MODERNIZATION AT CURRAN MIDDLE SCHOOL FOR:

BAKERSFIELD CITY SCHOOL DISTRICT

INTERIOR ELEVATIONS BUILDINGS D & E

A-236

D2 INSTRUMENTAL E-101
1/4"=1'-0"

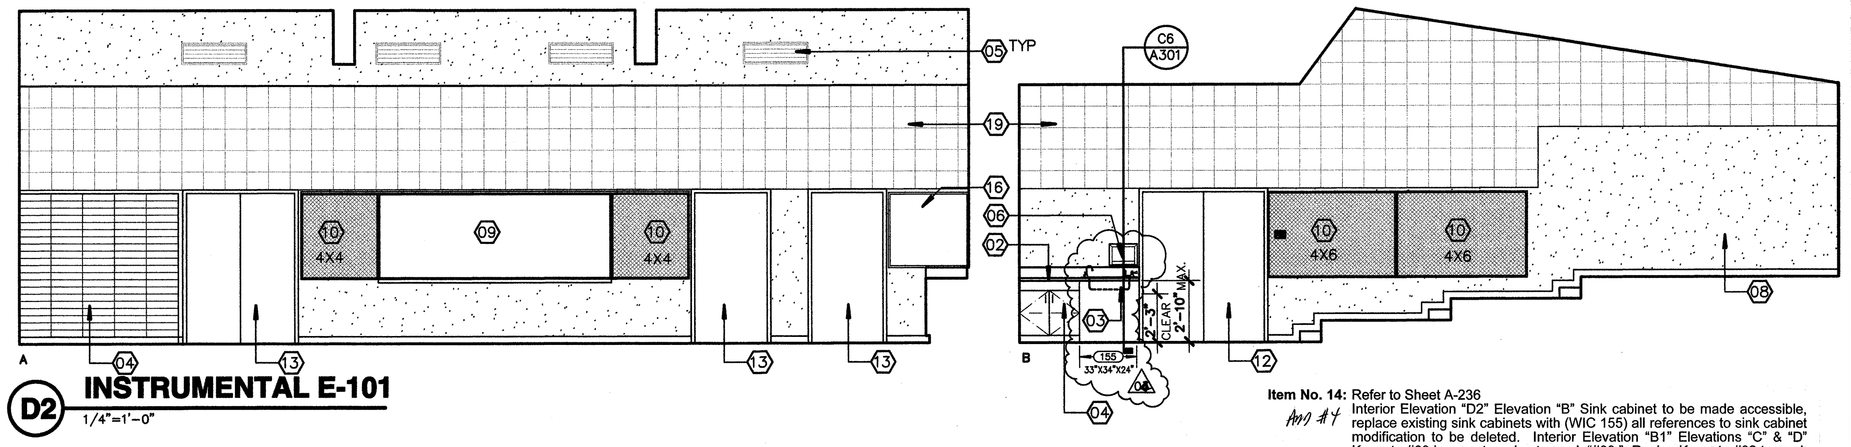
Item No. 14: Refer to Sheet A-236
App 4 f
Interior Elevation "D2" Elevation "B" Sink cabinet to be made accessible, replace existing sink cabinets with (WIC 155) all references to sink cabinet modification to be deleted. Interior Elevation "B1" Elevations "C" & "D" Keynote #09 incorrect, revise to read. "#08." Revise Keynote #02 to read. "Remove and replace existing counter top with corian countertop with 6" splash (unless noted otherwise) calk to wall typical." Revise Keynote 03 to read. "Replace existing sink cabinet with ADA compliant sink cabinet, typical all sink cabinets." Revise Keynote #4 to read. "Existing cabinet to remain, remove and replace all doors, drawer fronts, & face plates. Finish per specifications." Revise Keynote #21 to read. "Provide and install corian counter top with accessible sink cabinet. Return flooring to wall, wrap supply and waste lines with insulative tape. See plumbing plans for further requirements."
